Comments Regarding Predictive Simulations 1 through 4 and Preliminary Evaluation of Potential DFCs for the Simsboro Aquifer

March 27, 2015

Steven Young Phd, PE, PG

Critical Assumption in PS4

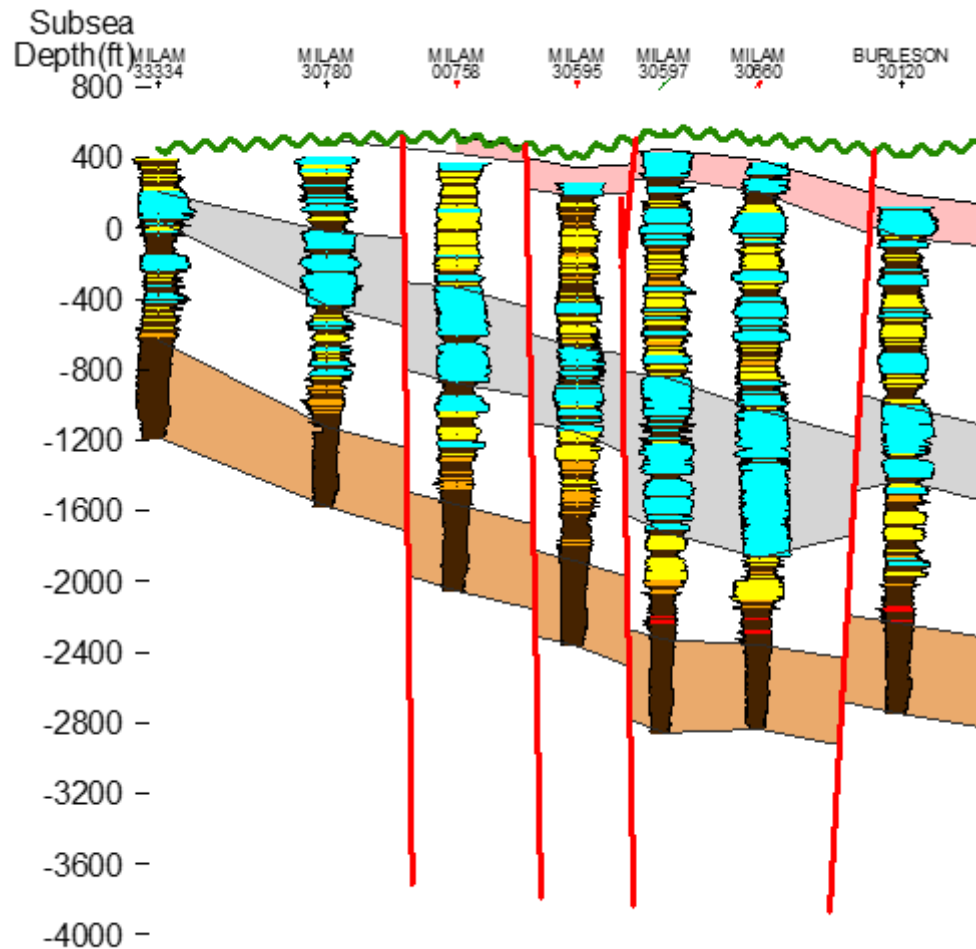
- Majority of faults in Milam & Burleson County are sealing faults
- Sealing faults are assigned a hydraulic conductivity of 0.0001 ft/day (about 1/10,000 the value of sand)

Comparison of Model to Measured Water Level Data for 2010

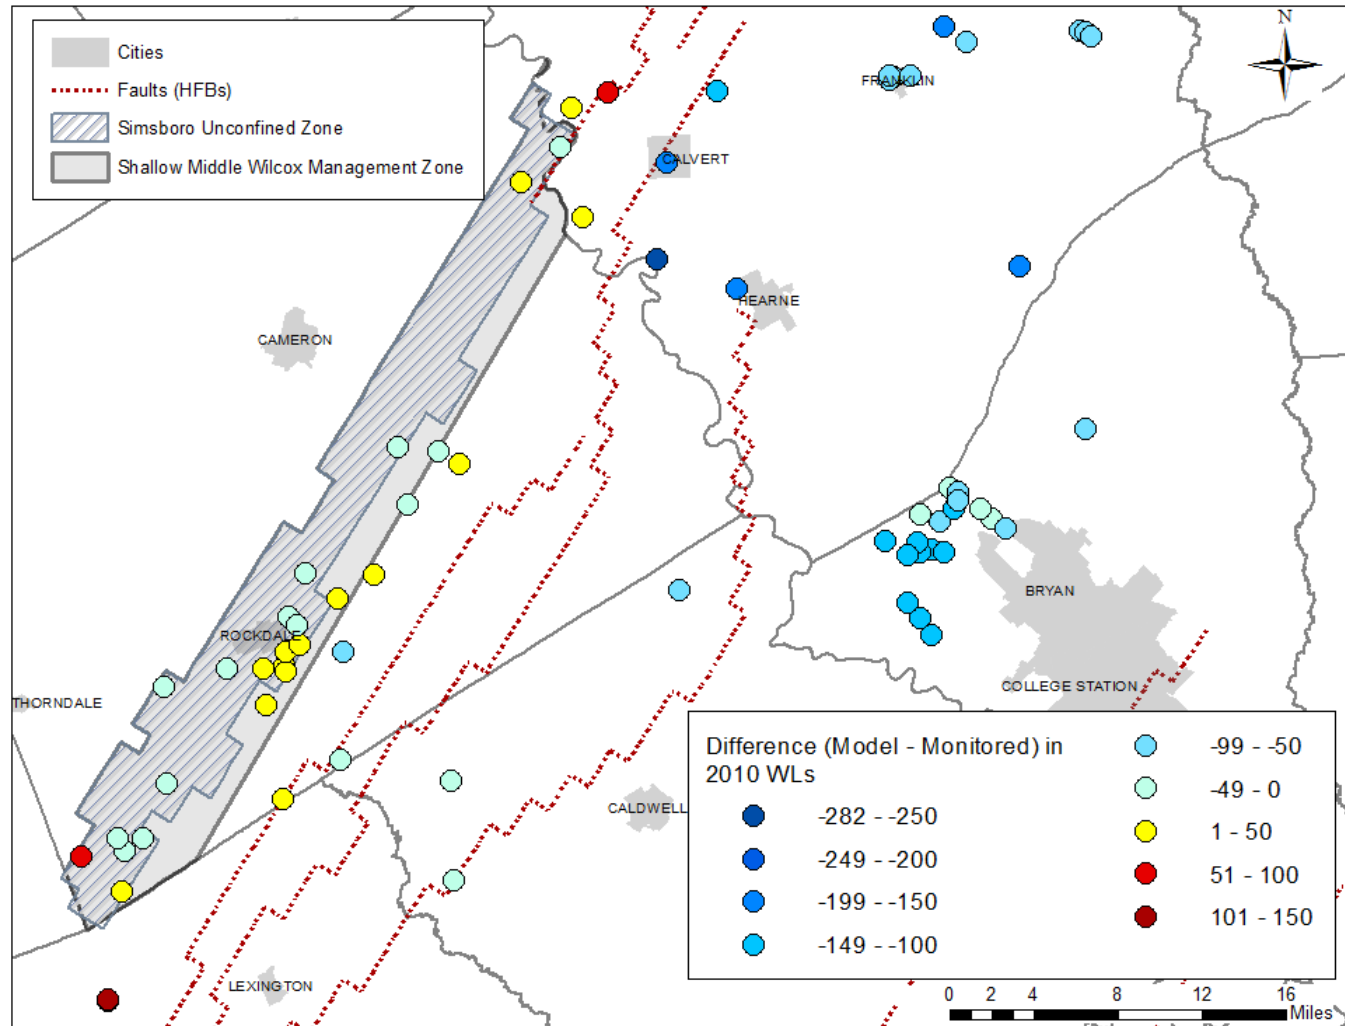
Blue or Negative means GAM is over predicting drawdown

2010 Simsboro Water Column (water level – bottom aquifer)

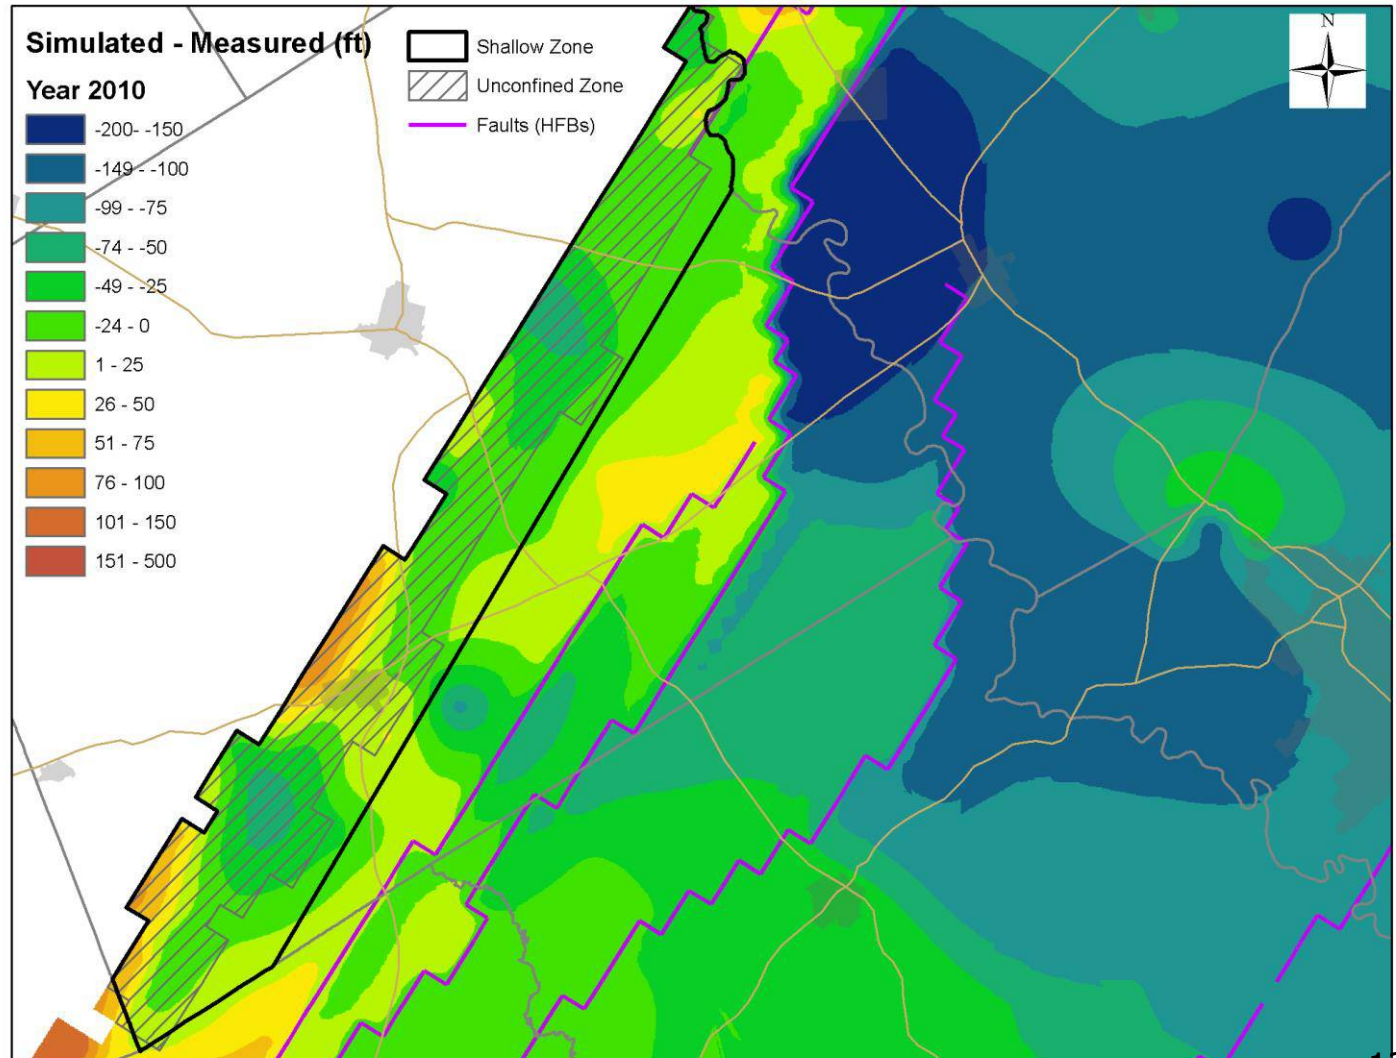
**Blue or
Negative
means GAM
is over
predicting
drawdown**

Preliminary Evaluation of PS4 Predictive Uncertainty

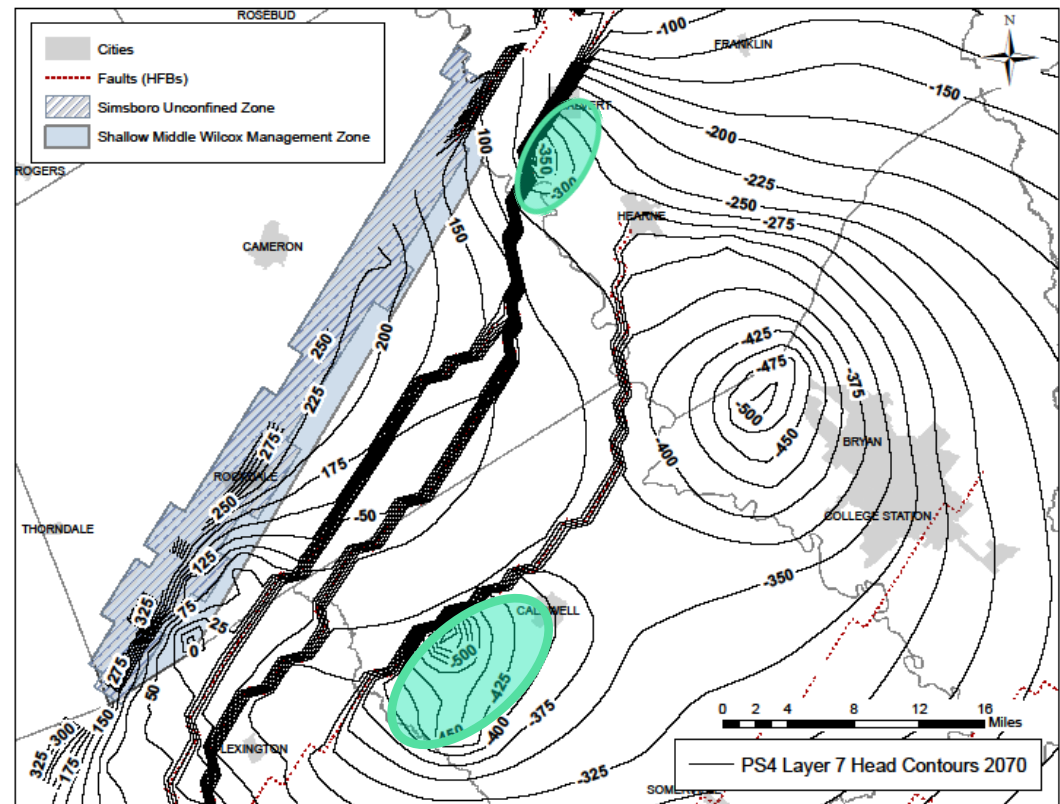
- PS4 runs likely will over predict drawdowns and especially near the faults
- PS4 runs likely will over predict drawdowns in shared regions by more than 200 feet in 2070
